**RESPONSE TO RIX'S CREEK IPCN QUESTIONS**  
**Arising from Briefing held 25 May 2018**

**Figure 1:** Comparison of SSD identified offset areas vs Mod 5 offset areas

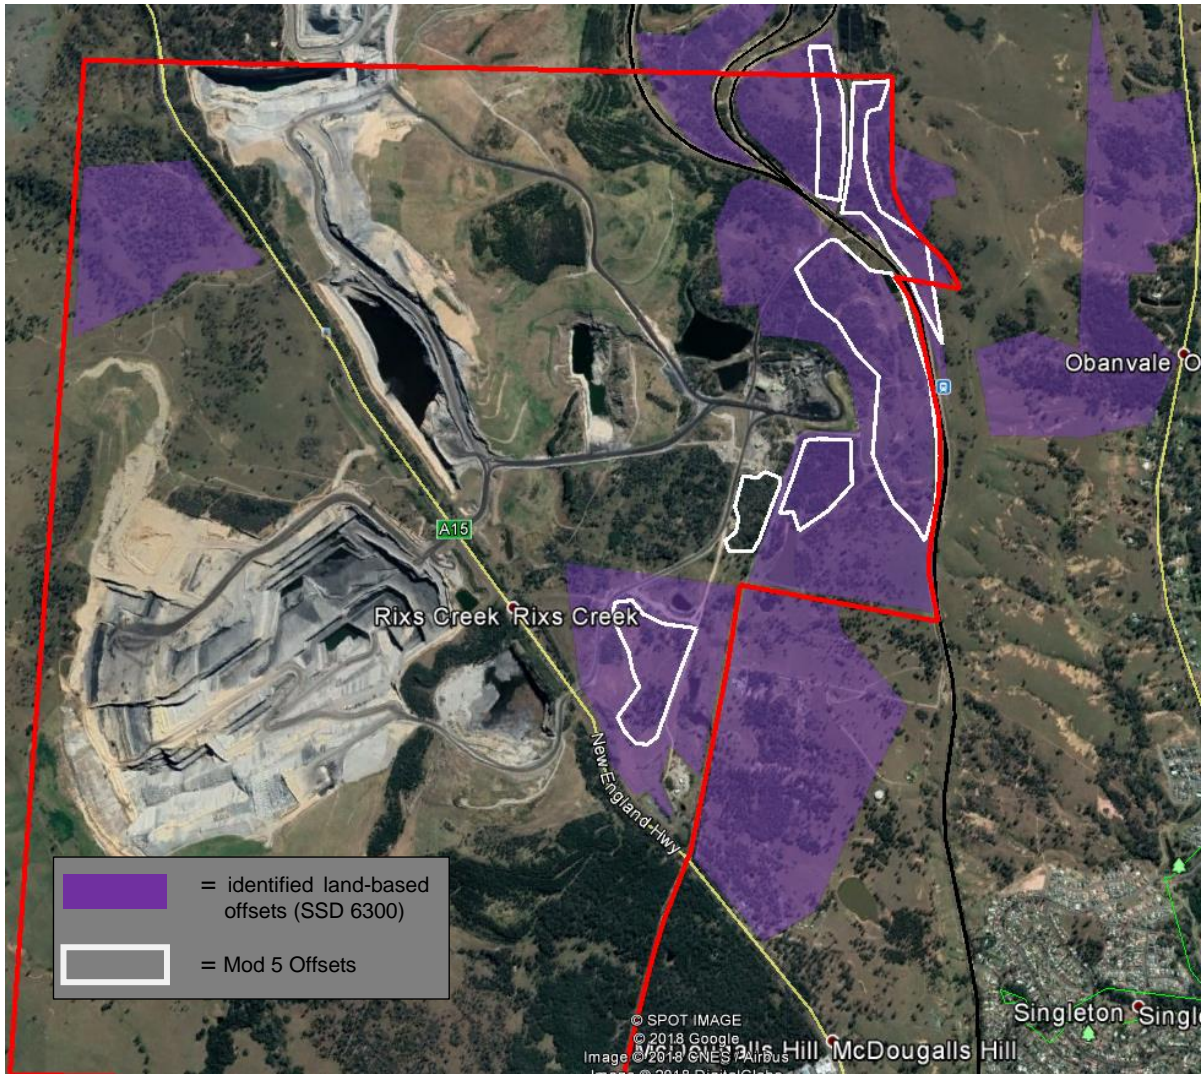
6. *Do the land-based offsets identified in Table 10 of the PAR and Table 5.1 of the Revised Biodiversity Assessment (March 2018), include the 118.3 ha of land previously designated as the offset for Mod 5 (to be surrendered)?*

The land-based offset areas identified includes the great majority of the offset areas identified for Mod 5. See **Figure 1** below. The purple areas indicate the identified land-based offsets under SSD 6300, the white outlines show the offset areas identified for Mod 5. Please note that the boundaries in this Figure are indicative only.
